## **Victorian Planning Authority**

### **Amendment C243 to the Hume Planning Scheme Review of Documentation relevant to the ICP**

October 2020

Figure 15: Lancefield Road/Sunningdale Avenue Interim Signalised Intersection Modified with Taper (LR-IN-01)

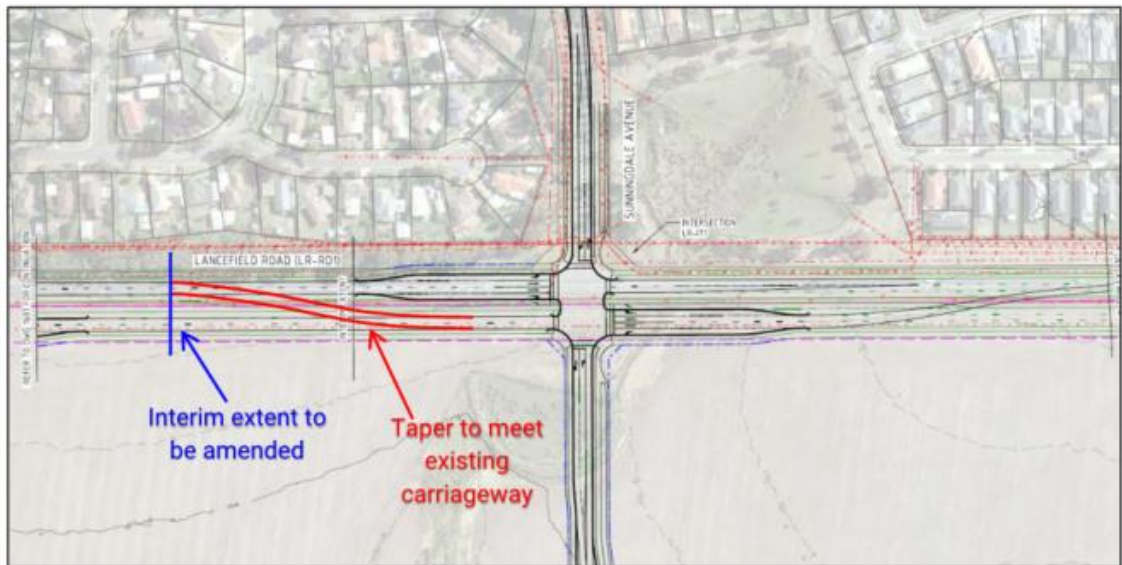
Mr Turnbull identified an issue with the interim design at the intersection of Lancefield Road and Sunningdale Avenue referred to as LR-IN-01. The current design shows the southbound leg of Lancefield Road being duplicated and constructed in the ultimate road configuration.

Mr Turnbull has identified that the southbound leg of Lancefield Road should taper and connect to the existing roadway and not be constructed in the ultimate design, refer Figure 15 below from Mr Turnbull's report.

GHD has reviewed the design and agrees that Lancefield Road sits outside the ICP elements identified in the current design and costings, coupled with unknown staging of development in the precinct it should be assumed that that the intersection will connect to the existing Lancefield Road and not the ultimate design.

VPA  
SUNBURY STH AND LANCEFIELD RD PSP  
JACKSON CREEK - LR-BR-01  
PLAN AND LONGITUDINAL SECTION - SHEET 1 OF 2

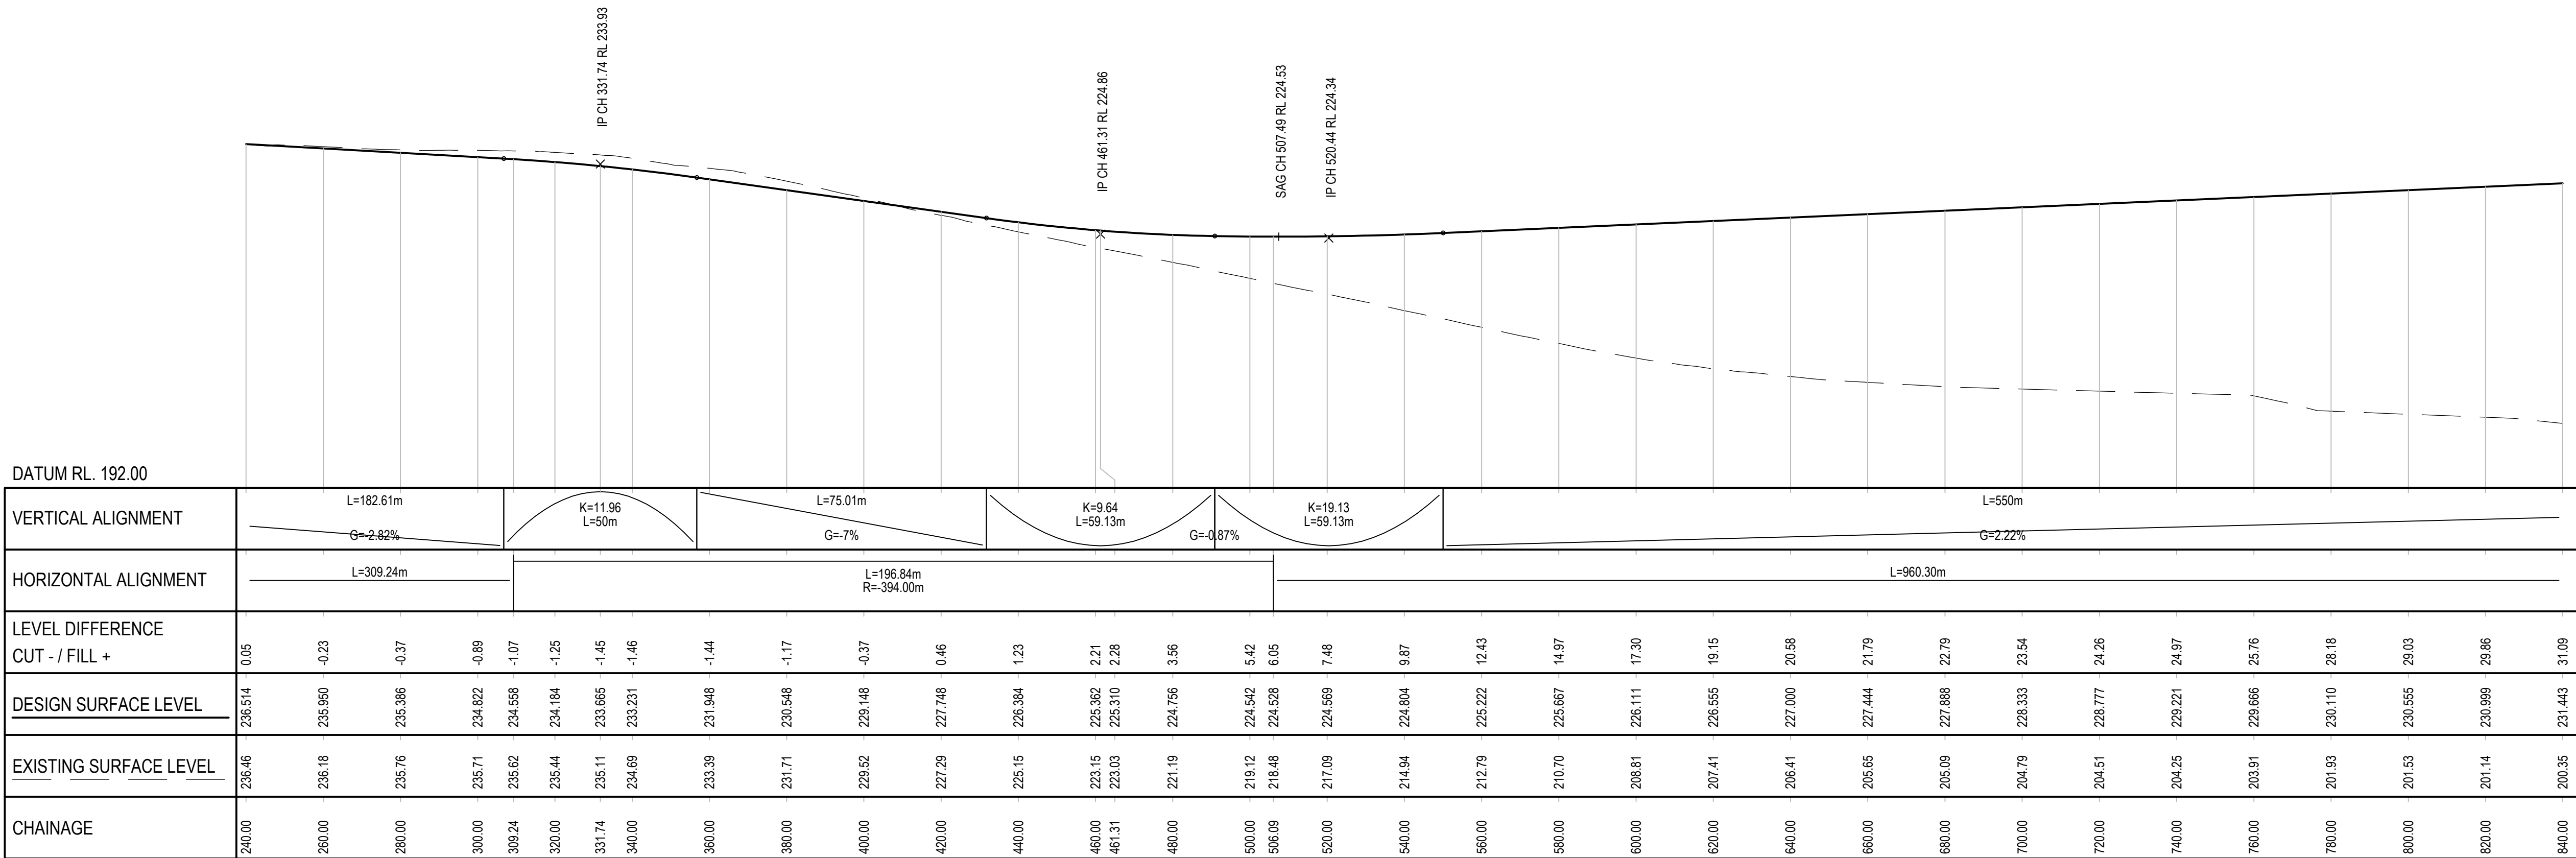
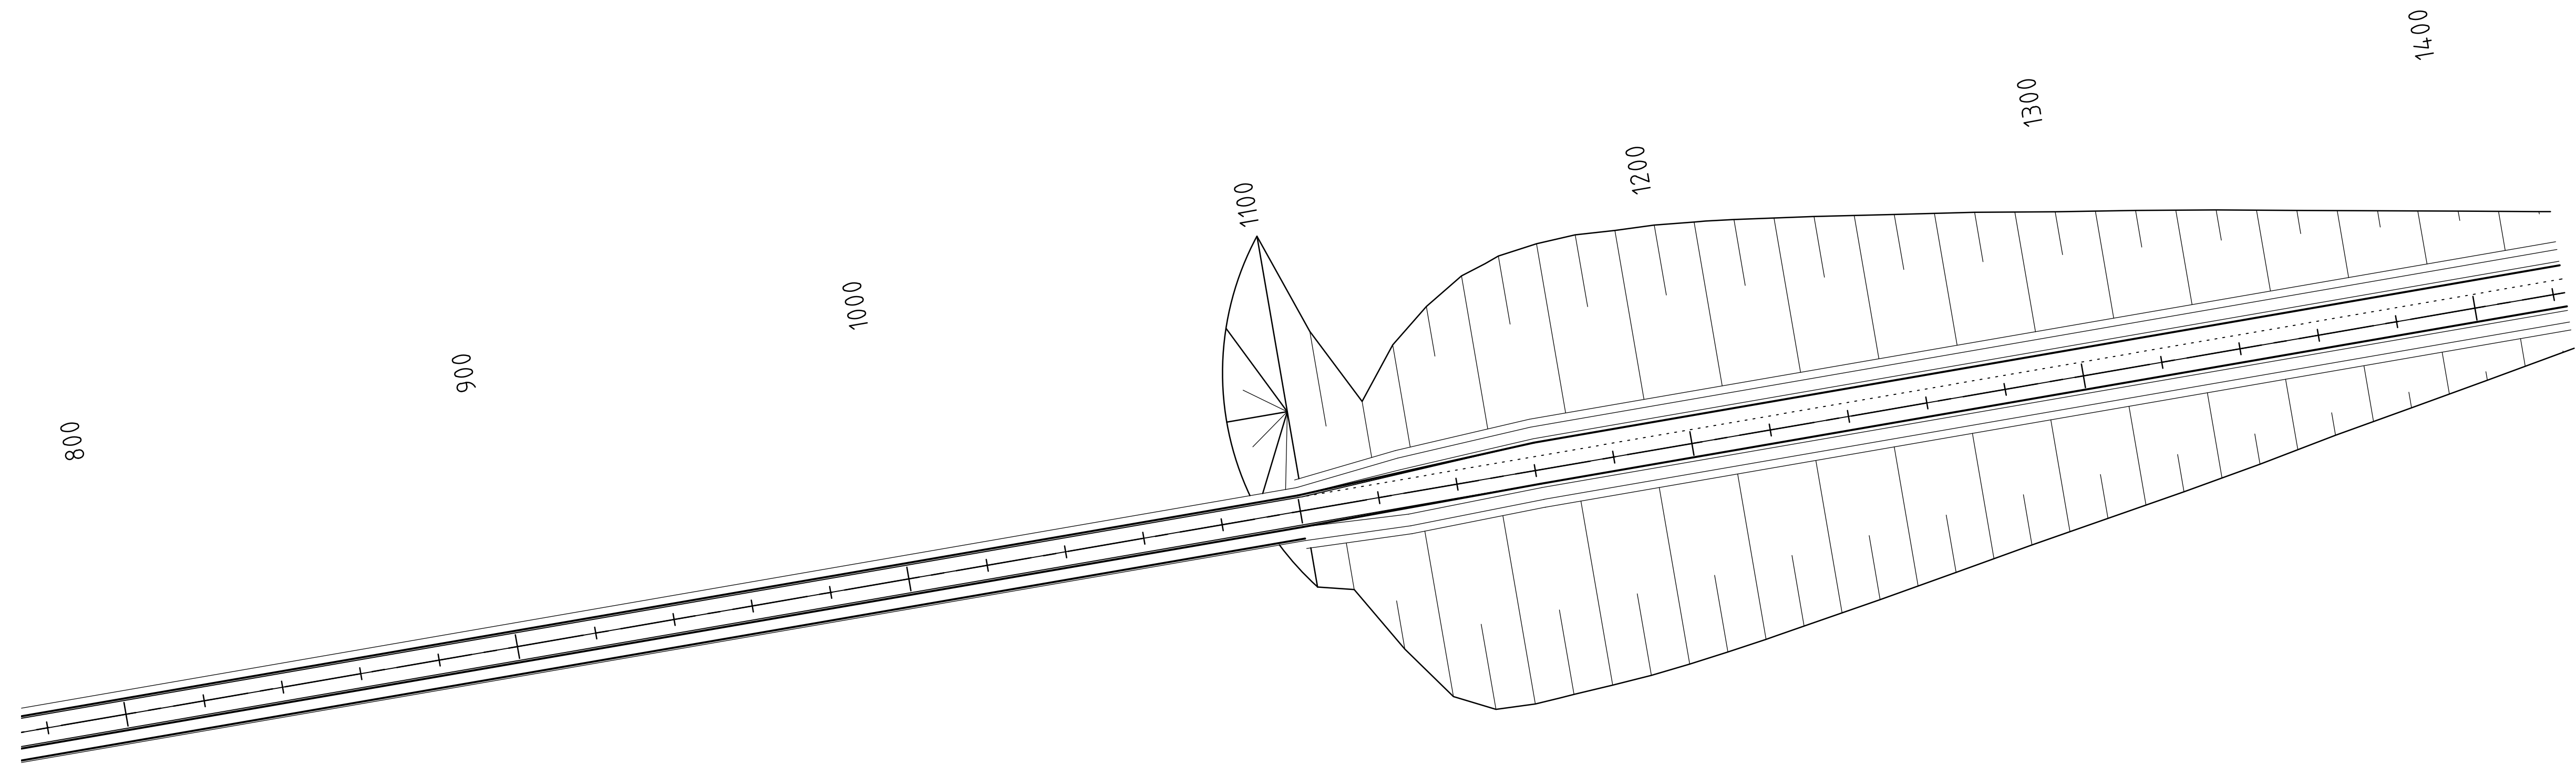
Upon review of the previous design work completed by Parsons Brinkerhoff for LR-BR-01 GHD reviewed the overall bridge gradients and noted some improvements could be made to reduce gradients from maximums to preferred, which would facilitate a better driver experience. GHD adopted road grading varied from 2% to 7% over 300 metres on the western side with a 2% grade on the bridge and a 7% grade on the eastern side of the bridge over approximately 205 metres up the escarpment with a maximum cutting through the escarpment of 13.99 metres, refer Appendix A for long sections.

This resulted in a bridge with 8no 50 metre spans and 2no 45 metre spans totalling 490 metres approximately 35.5 metres above Jackson Creek. Due to the length of the spans a steel box girder bridge was selected using 3 units per span with a depth of 3.0 metres. The bridge cross section is 13.5 metres between kerbs comprising two 3.5 metre traffic lanes and one 2 metre and one 3 metre shared pathway. These details are shown in the drawings in Appendix A.
